PROJECT: Oran K. Grayson Elementary School Addition

CITY OF LAS VEGAS INTER-OFFICE MEMORANDUM		DATE: February 4, 2021
TO: Land Development Services Department of Building & Safety		FROM: Albert Sung, P.E. Flood Control Project Engineer Department of Public Works
SUBJECT:	Drainage Study for:	
	Oran K. Gragson Elementary School Addition	
Cross Streets:	SEC of Bonanza Road & Honolulu Street	
File Number:	F:\Depot\DSMemos\DS5392B.doc	
Parcel Number:	140-31-102-003	
Zoning Action:	20-0301-SDR1 & 20-0301-VAR1	
FEMA Flood Zone	YES	NO X
Proposed Storm Drain	YES	NO X
COPIES TO:		Lochsa Engineering
		School Board of Trustees
		Bart Anderson, P.E., DevCo

Addendum to the Technical Drainage Study for the Oran K. Gragson Elementary School Addition

Subject: **Addendum to the Technical Drainage Study for Oran K. Gragson Elementary
School Addition
CLV DS5392A
Parcel Number 140-31-102-003
Lochsa Job #201091**

OFFSITE BASIN EXHIBIT OF1

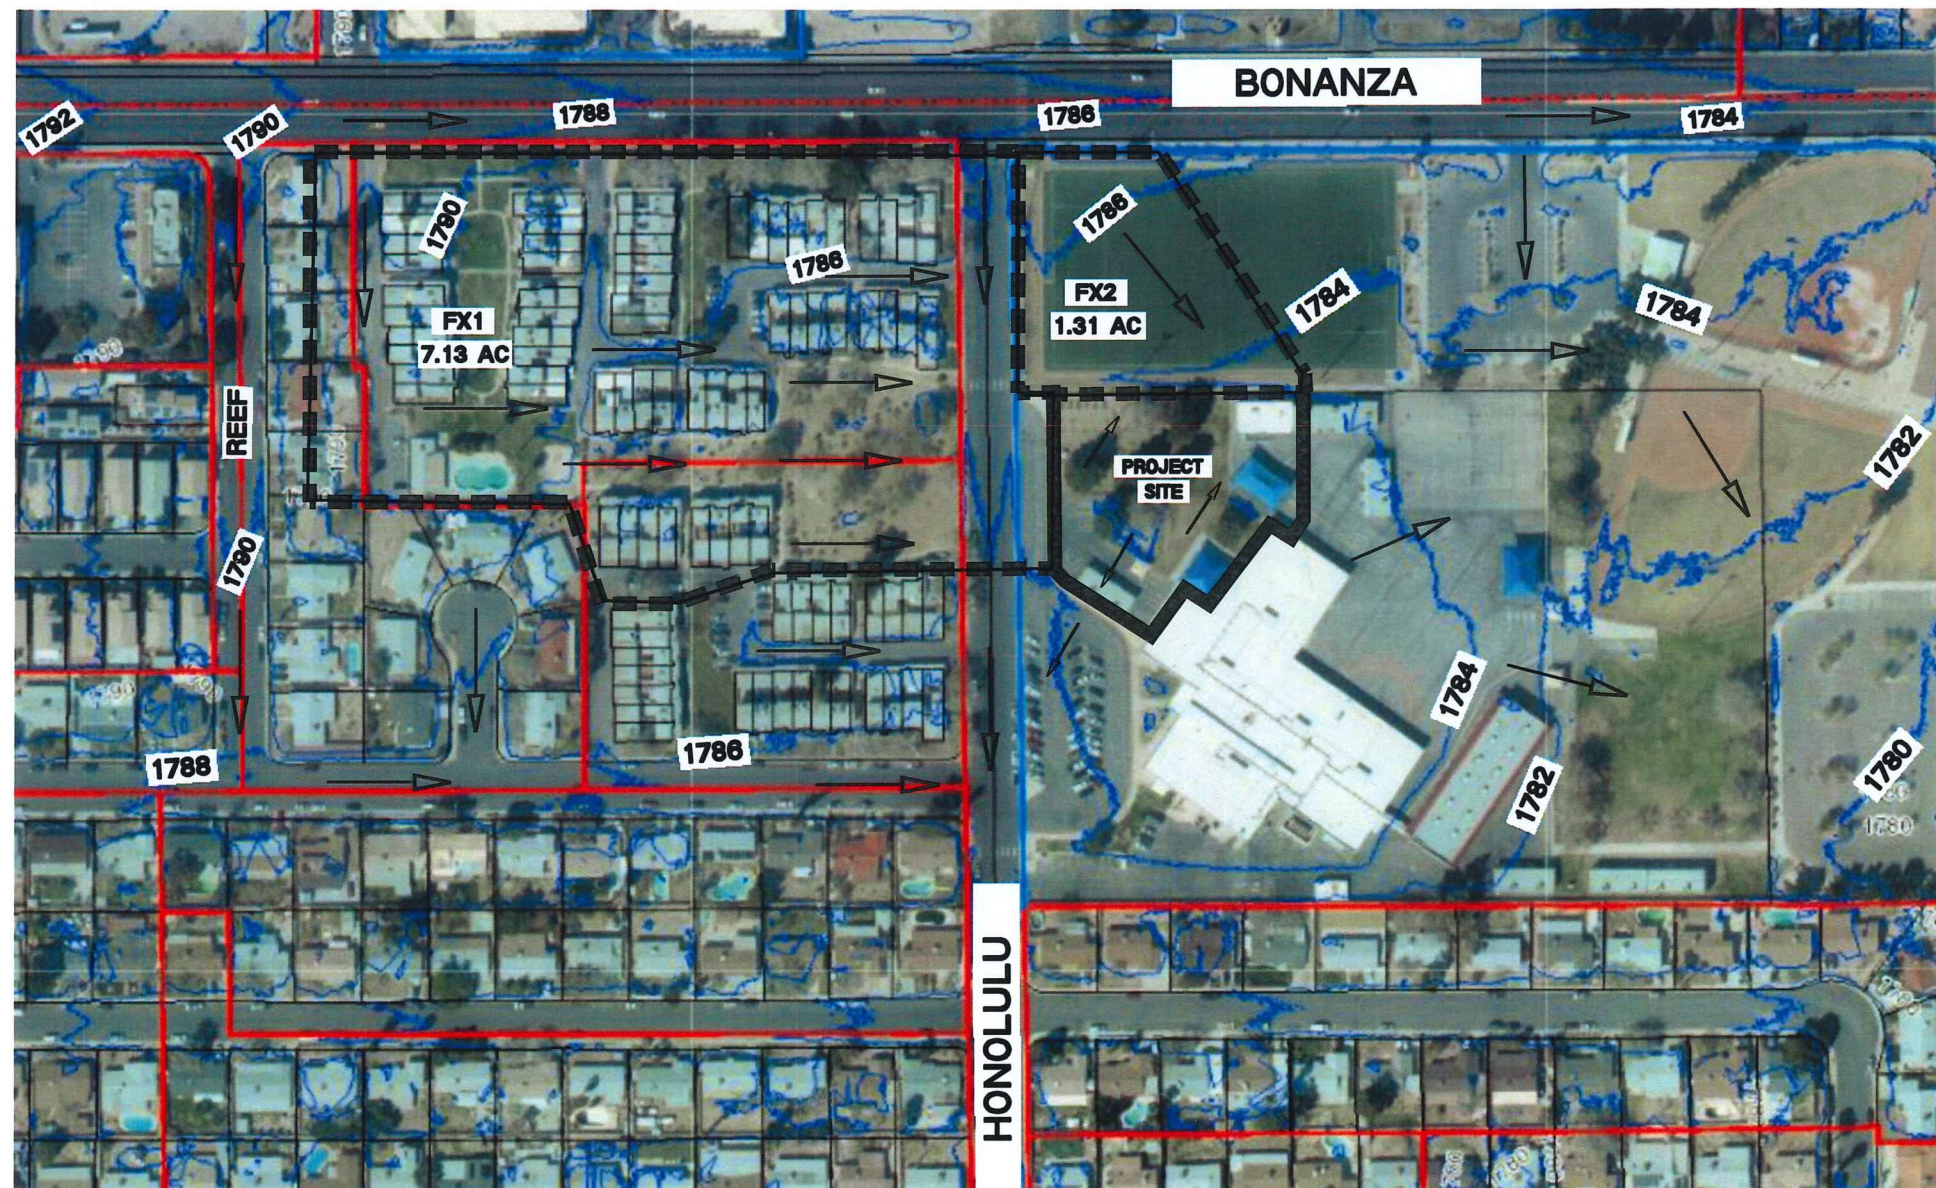
2. Page 3 of the *Study* stated that an offsite exhibit (Figure OF1) has been created and included in Appendix C. It also said that offsite basin FX1 was determined to impact *Honolulu Street* west of the subject site. However, no such figure was found in Appendix C.

In **DR1** and **DR2** (Existing and Developed Conditions Onsite Drainage Maps), *Basin FX1* was shown. However, without showing the whole basin and pertinent topographic information, it was not justifiable to merely stating that the basin area is limited to 7.13 acres. Resolve in the next submittal.

Response 2: Noted. We have provided the Offsite Exhibit OF1. This exhibit was left out by accident in the initial submittal.
